**Steven M. Clouse WRC Electrical System Improvements Phase II**  
**Solicitation Number: CO-00276**  
**Job No.: 16-6501**

**ADDENDUM 1**  
**February 22, 2021**

SHEET NO.  
**05E07**  
101 OF 500

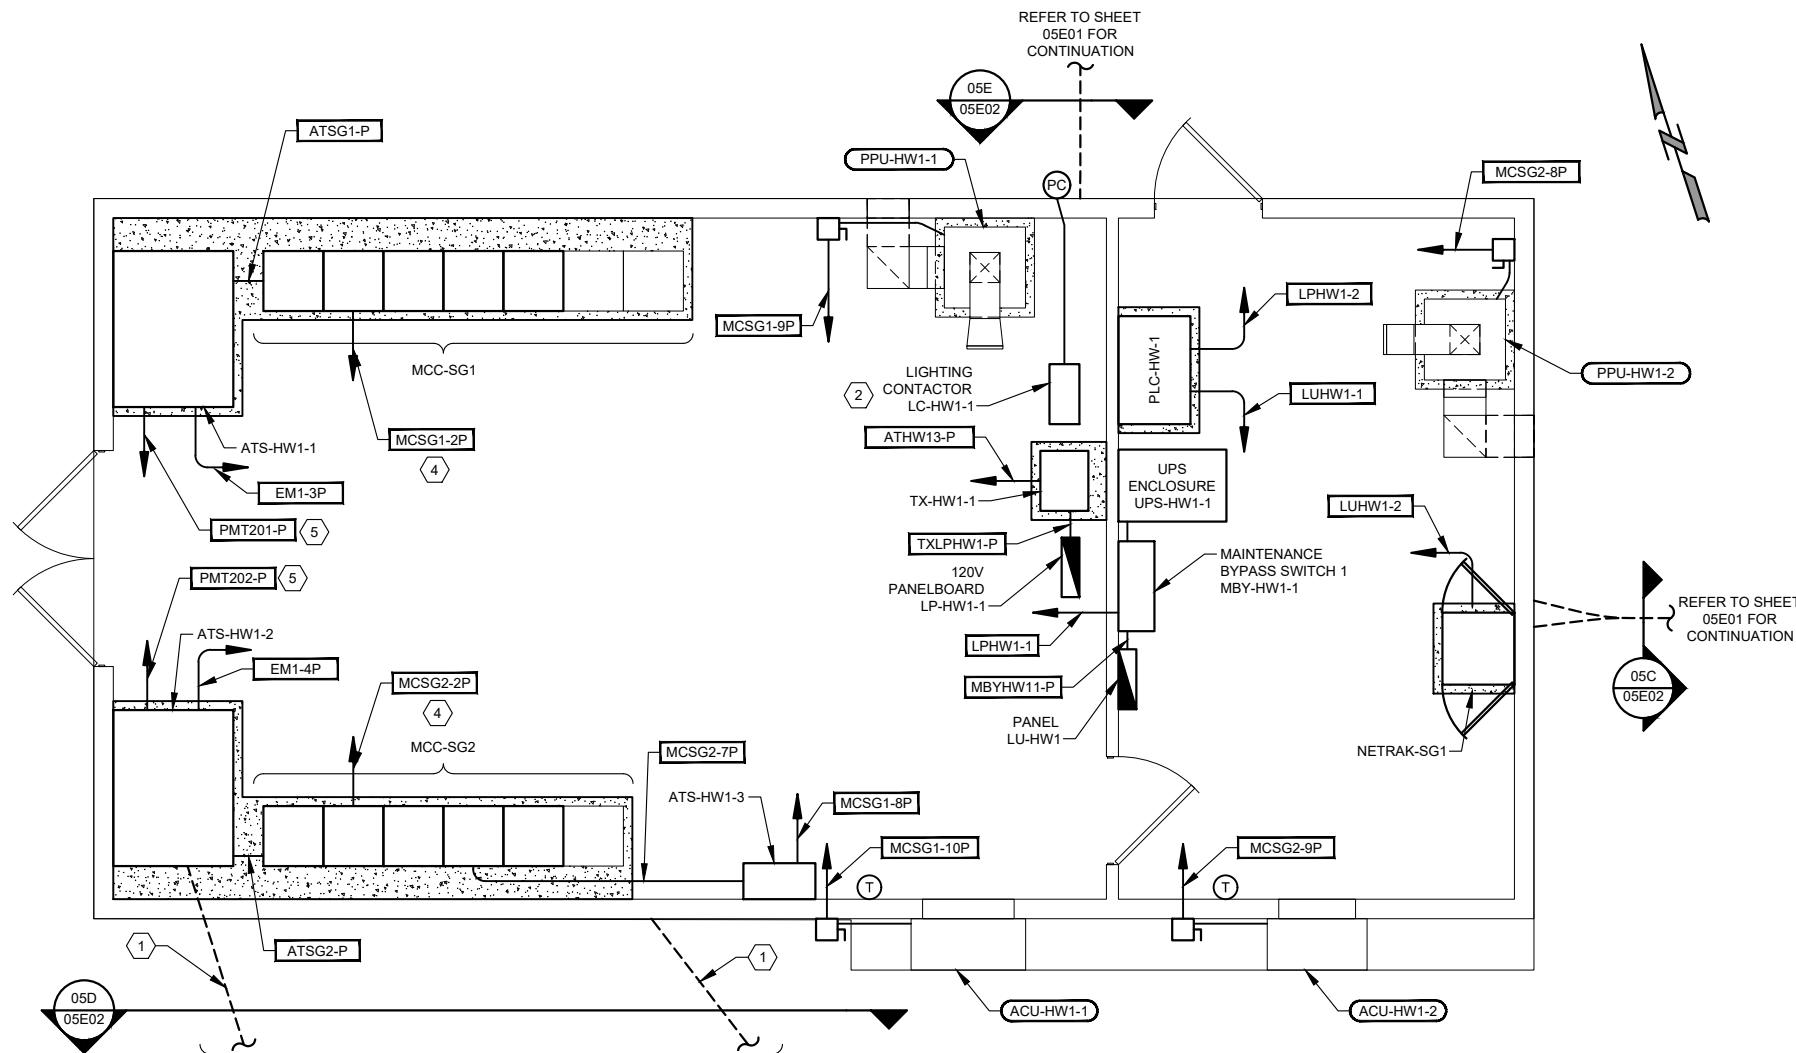
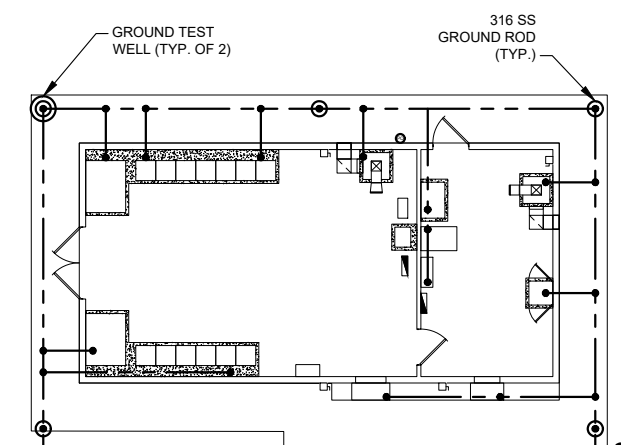
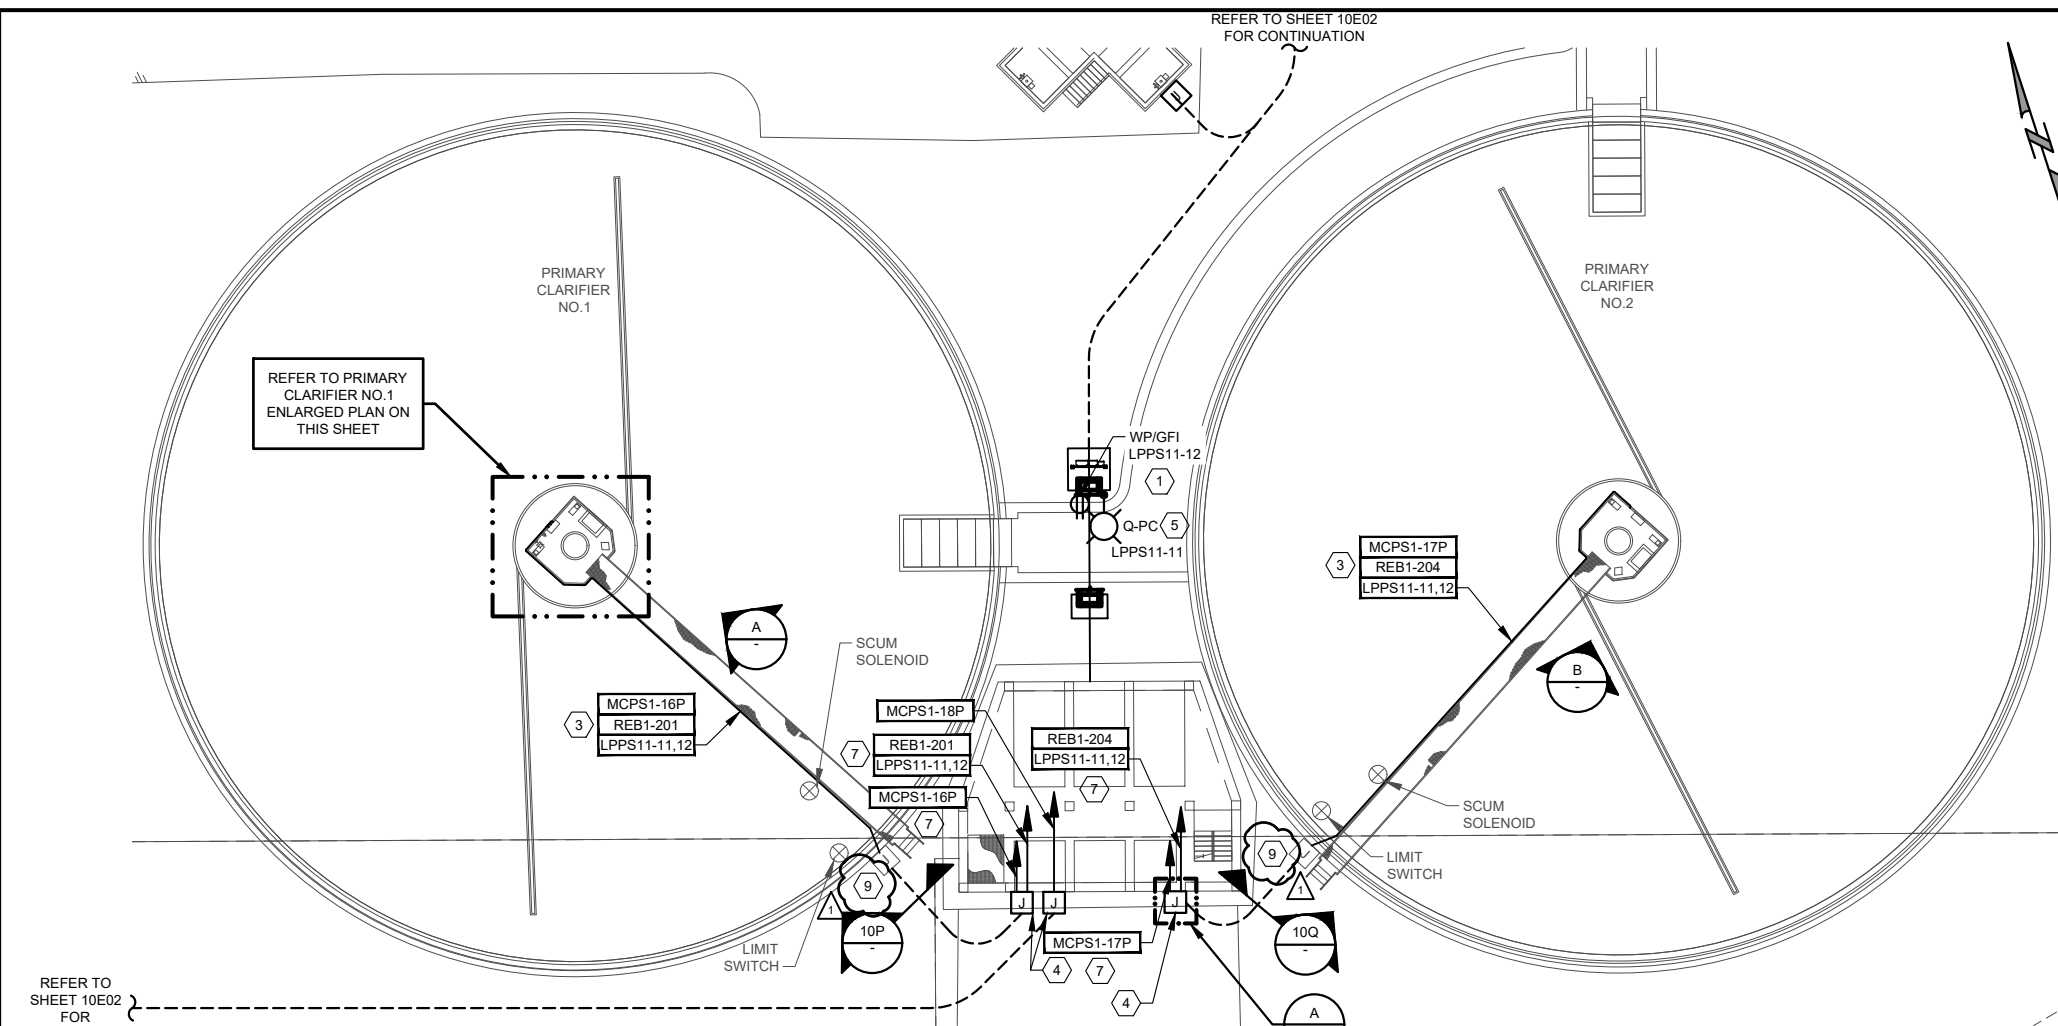
7. Lighting contactor referenced on Drawing 05E16 for Blower Facility Lights is not shown on the Blower Facility Drawing 05E13. Please clarify.

*Response: The lighting contactor is shown on sheet 05E07, schematic on sheet 05E18. (No reference found on sheet 05E16.) Refer to "Changes to the Plans," item 1.a.*

SHEET NO.  
**20E17**  
312 OF 500

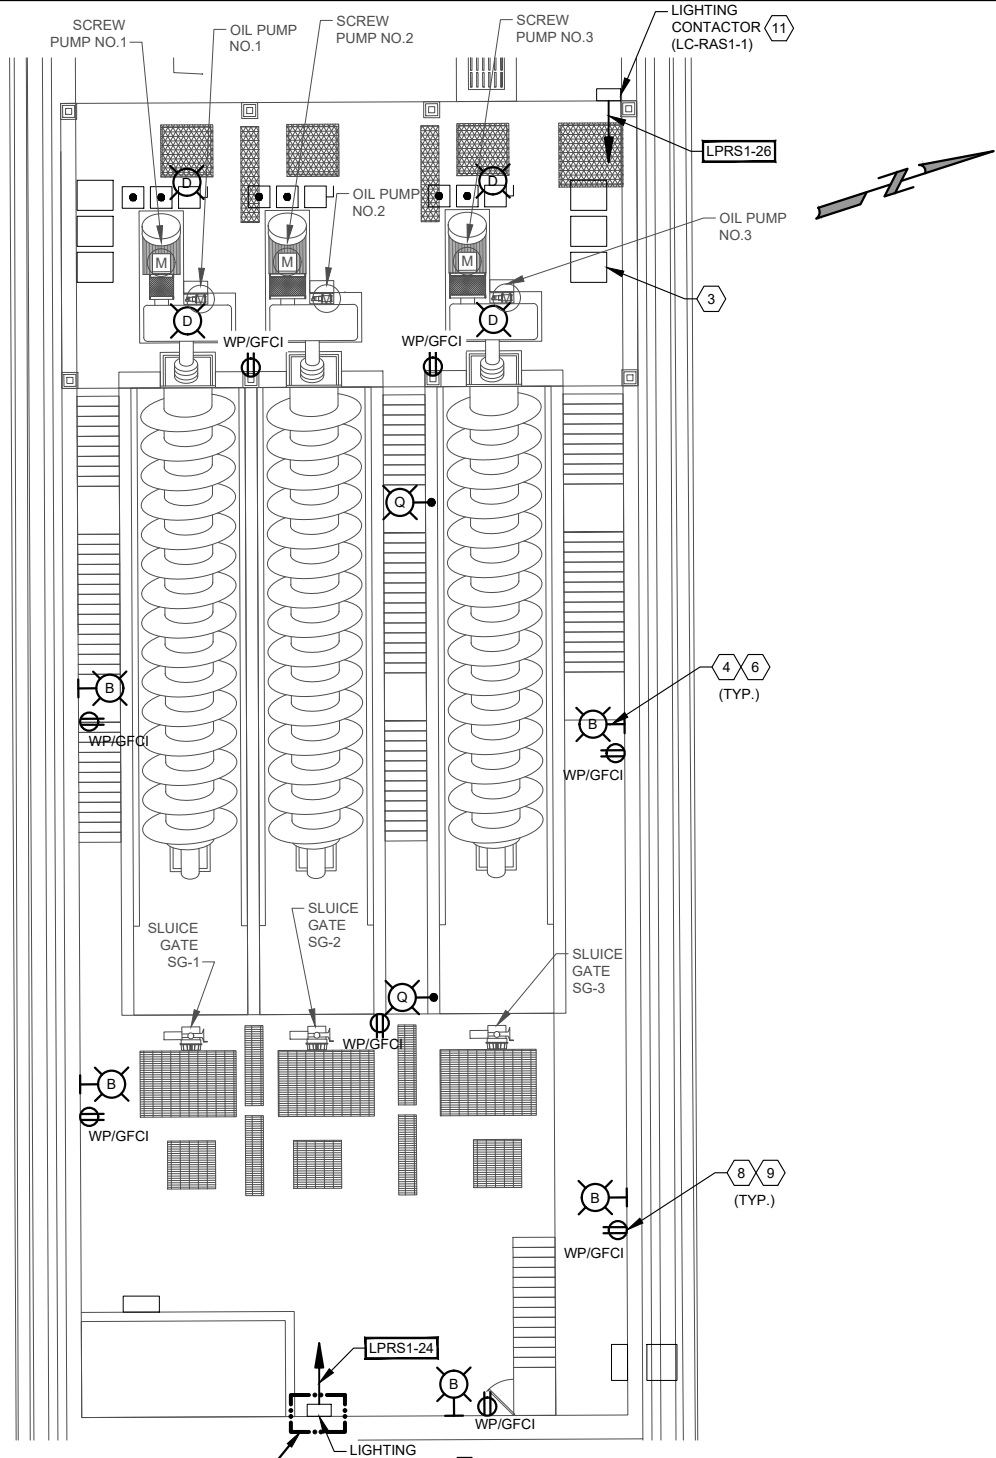
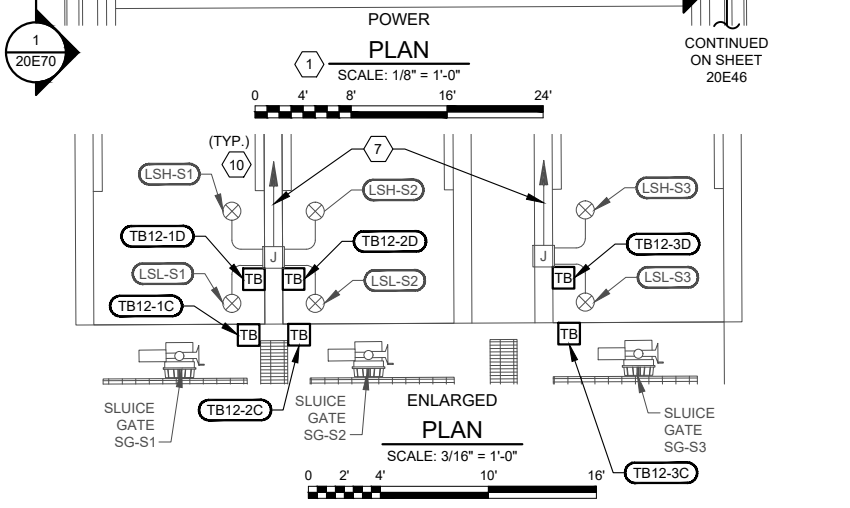
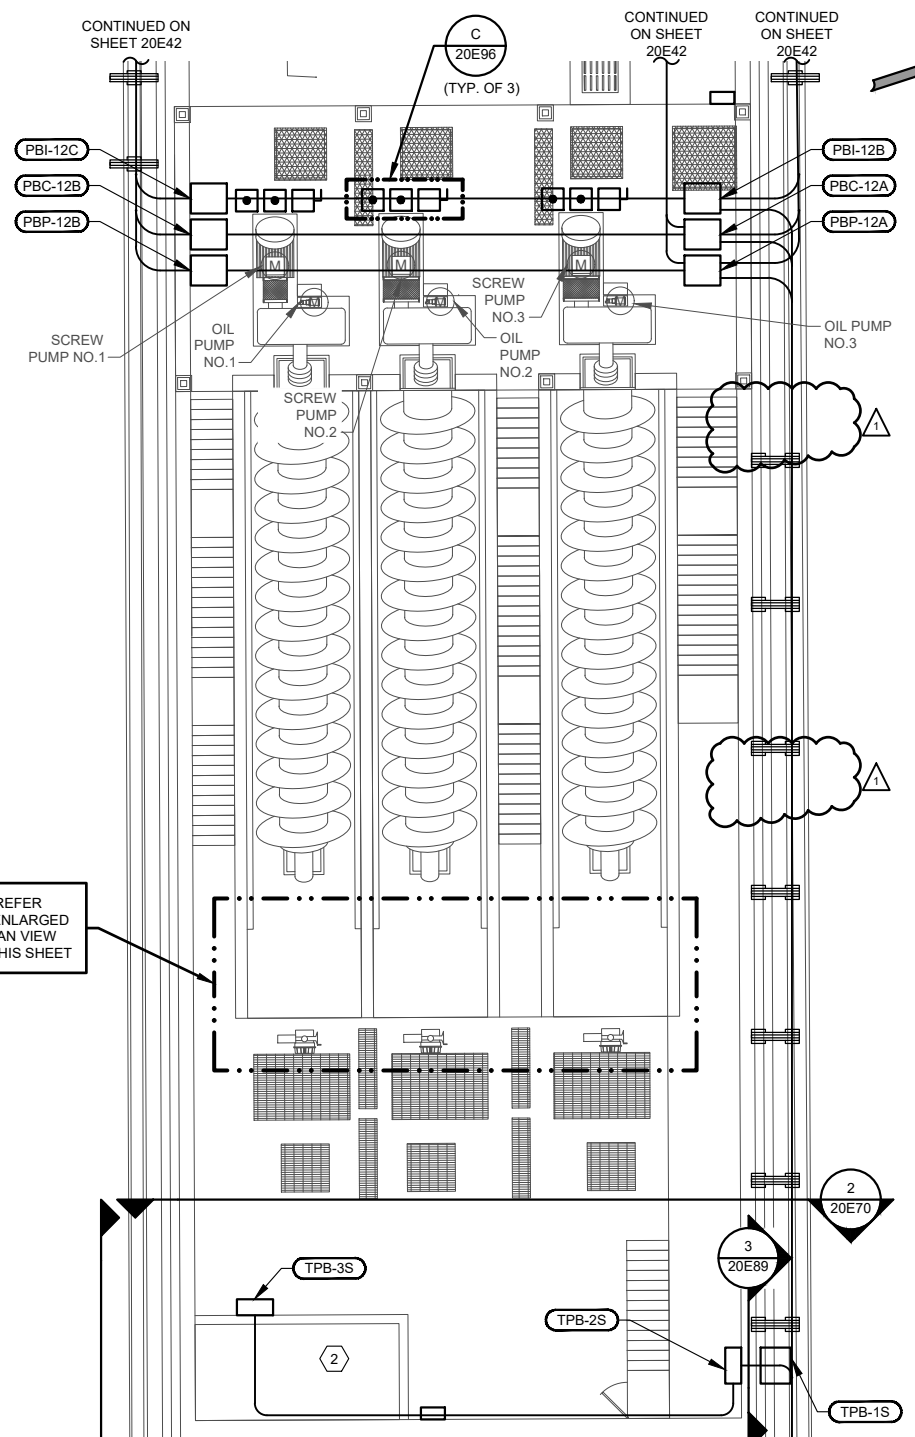
10. Drawing 20E62 RIO circuit # RIRS24-119 is utilized twice, one for Pipe Gallery cables from GMP-002 and again for MCC-RS-2. Please advise.

*Response: SPD in MCC-RS2 communication circuit changed to RIRS24-122. Refer to "Changes to the Plans," items 1.f and 1.i.*

20E39

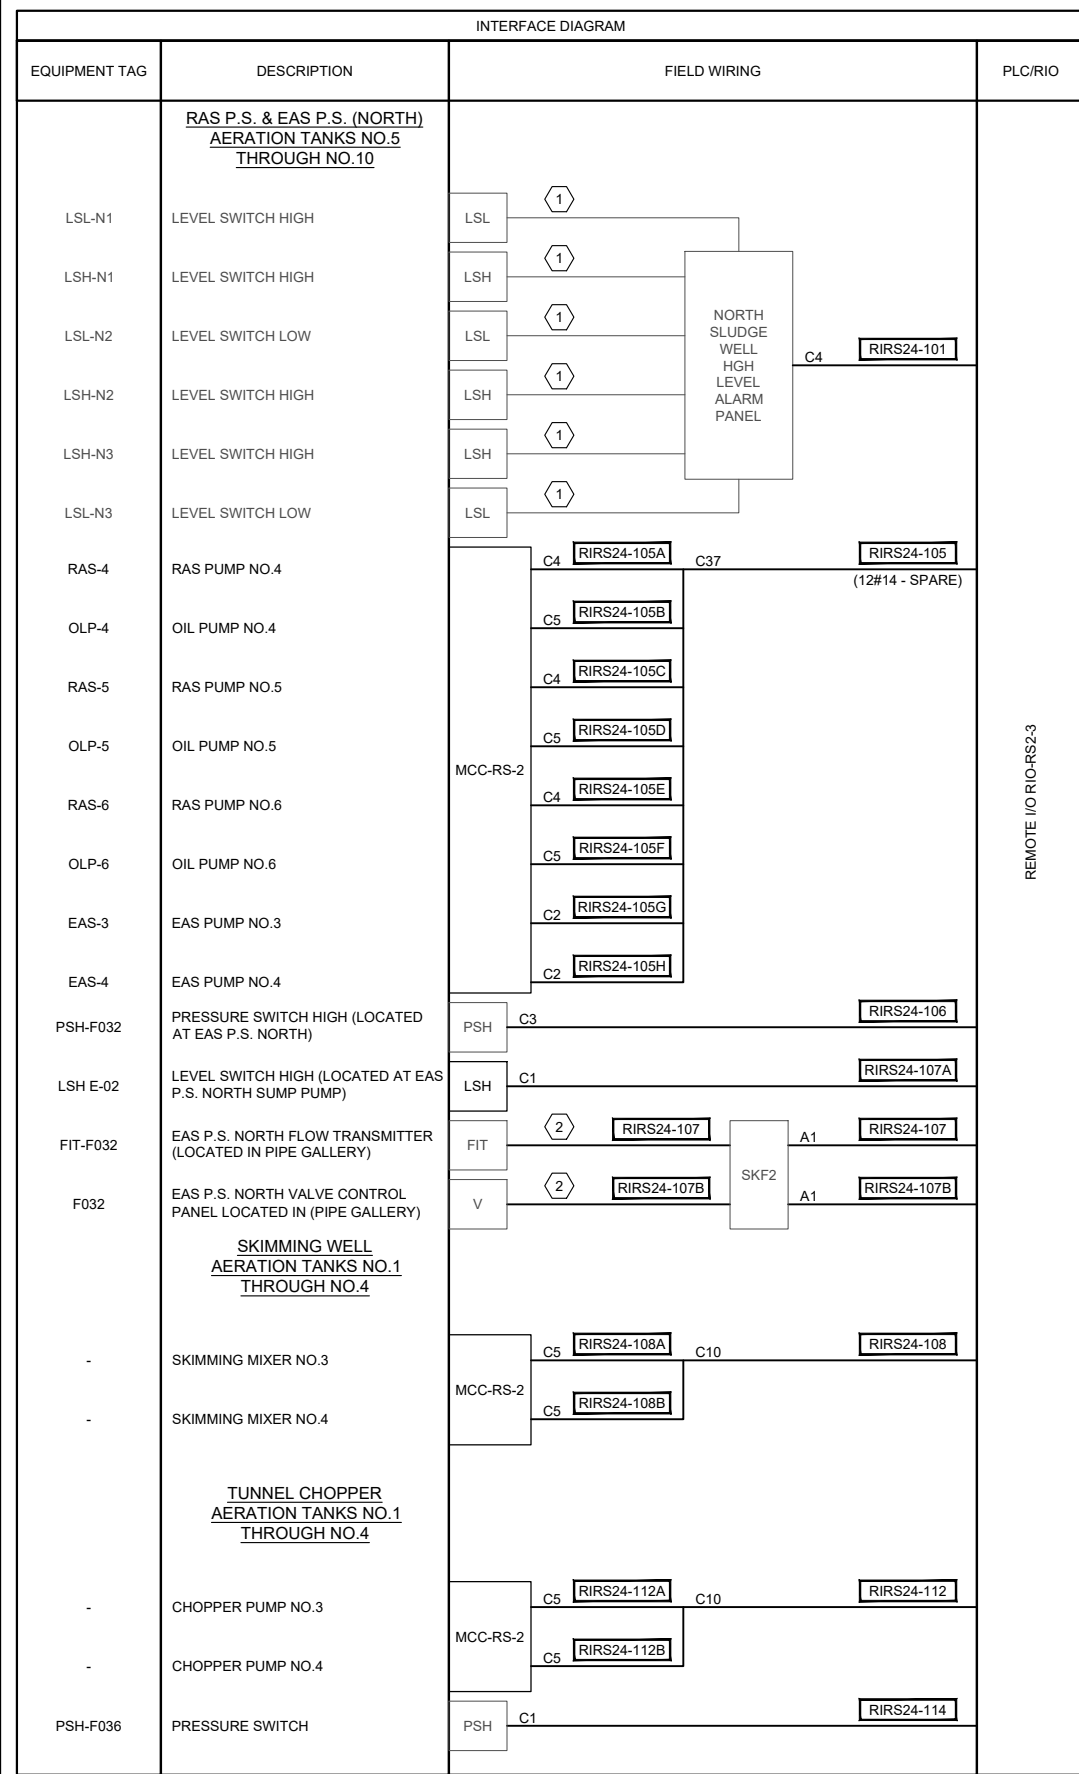
12. Drawing 20E39 & 20E40 shows Flow Element & Flow Indicating Transmitter and 2 LITs each. But no cabling details are shown in the riser diagrams. Please advise if these are to be rewired.

*Response: Refer to "Changes to the Plans," items 1.g and 1.h.*
